ECN/PCN No.: M1709

<b>Product Description:</b> RJ45 10/100/1000 Base-TX 1x4 Jack with Magnetic Module	<b>Abracon Part Number / Part Series:</b> ARJ14A Series	<input type="checkbox"/> Documentation only <input checked="" type="checkbox"/> ECN <input type="checkbox"/> EOL	<input checked="" type="checkbox"/> Series <input type="checkbox"/> Part Number(s)
<b>Affected Revision:</b> C	<b>New Revision:</b> D	<b>Application:</b>	<input type="checkbox"/> Safety <input checked="" type="checkbox"/> Non-Safety

**Prior to Change:**  
 Update housing details for ARJ14A-MA

**Before Change:**

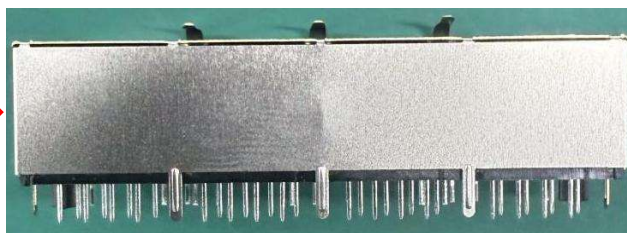
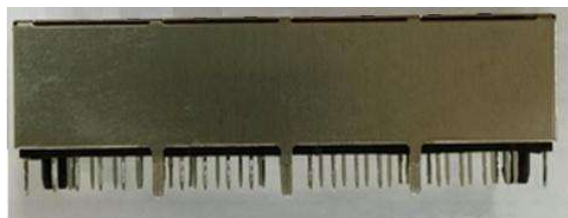
**After Change:**  
 There is some variation in the mechanical Dimentions and Housing look and no change in the electrical characteristics

**PC Board Layout  
Component Side Shown**

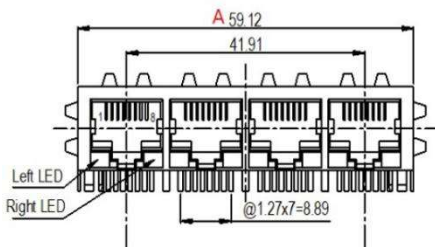
Before Change	After Change
A	59.12	58.74
B	21.50	21.10
C	13.60	13.40
D	3.30	3.50
F	10.90	10.70
I	1.70	1.60
K	1.00	1.02
M	58.93	58.54
